Calais at Pelican Bay

Project Management Report 20 – Building F

RE: Scope of Work Updates and Revisions – Unit F-303, Building F Post-Tension Cable Repairs/Replacement

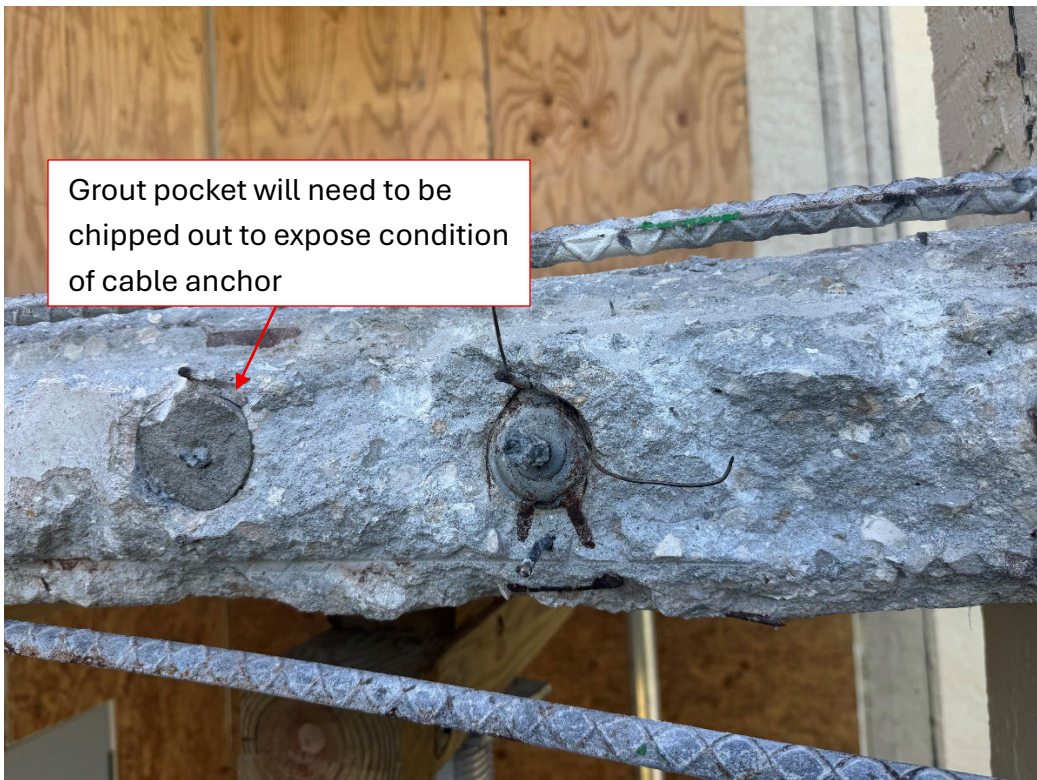
During the repair work on the three uniform cables emanating from the column in Unit F-303, additional exposure and chipping of the slab edge revealed three additional uniform cables located to the left of the originally identified cables. These newly exposed cables exhibit similar signs of distress:

- Slight corrosion on the edge reinforcement steel with insufficient concrete coverage
- Corrosion on the cable anchors
- Evidence of water intrusion, likely originating from fastener holes at the top of the slab edge where the screen enclosure was attached

The corrosion patterns observed align with the locations of these fastener holes, suggesting they are a primary source of water intrusion contributing to the deterioration of both the reinforcement steel and the post-tension cable anchors.

To develop a comprehensive and accurate repair scope for these compromised cables, Elias Brothers will expose the slab edge of Unit F-305 at the location where damage was observed. This exposure will allow us to confirm the prediction that all of these additional cables extend the full length of the building to this edge, rather than terminating at interior locations as indicated on the original structural plans and verify whether these cables are configured as

double live end cables. Once the slab edge of Unit F-503 is exposed, we will assess the condition of the cables and provide a revised repair scope.

Unit F-303 balcony slab edge: 3 additional uniform cables adjacent to the 3 originally exposed cables.

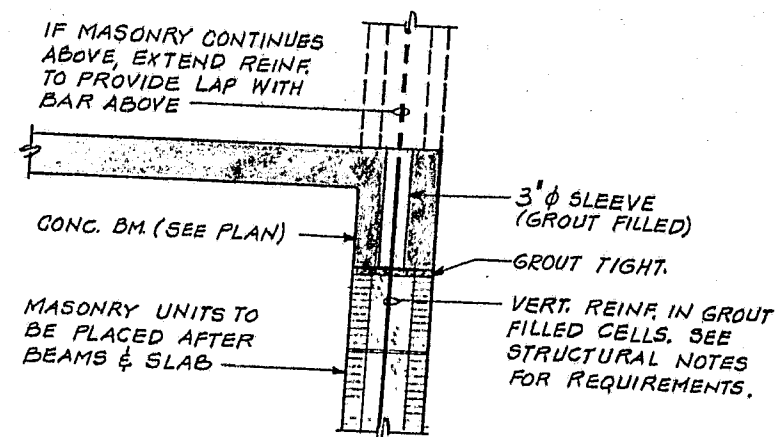
Unit F-305 condition: damage observed at balcony slab edge. Full exposure will be necessary for proper assessment.

TYPICAL FLOOR FRAMING PLAN
1/8" = 1'-0"

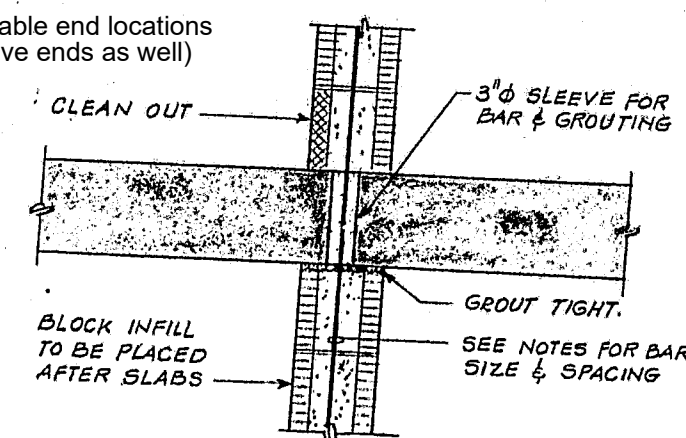
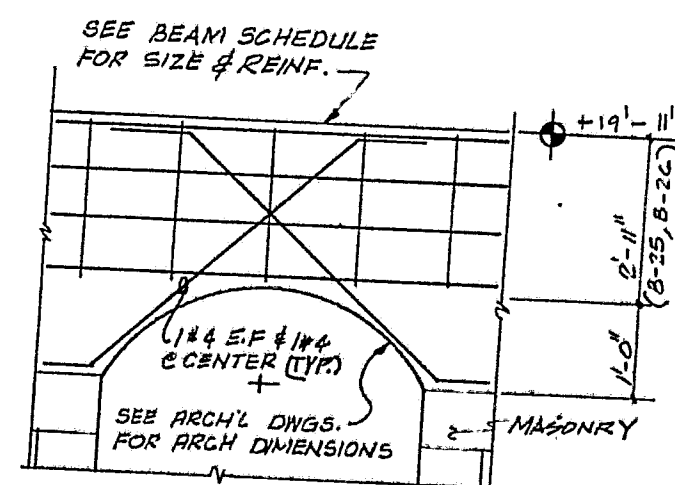
Based on the structural plans originally provided, the three uniform cables emanating from the column in Unit F-303 were assumed to have their live end (where stressing occurs) at the balcony slab edge of Unit F-303 and their dead end (anchored end) between the interior of Units F-303 and F-304.

However, during the repair process and subsequent investigation by the PT Specialist, it was discovered that these cables may run across the full length of the building from Unit F-303 to Unit F-305 rather than terminating between F-303 and F-304 as shown on the plans. When stressing was attempted during the typical repair procedure (locking off, splicing,

Predicted Cable end locations (assuming live ends as well)

Structural plans reflect dead end of cable between Unit F-303 and Unit F-304
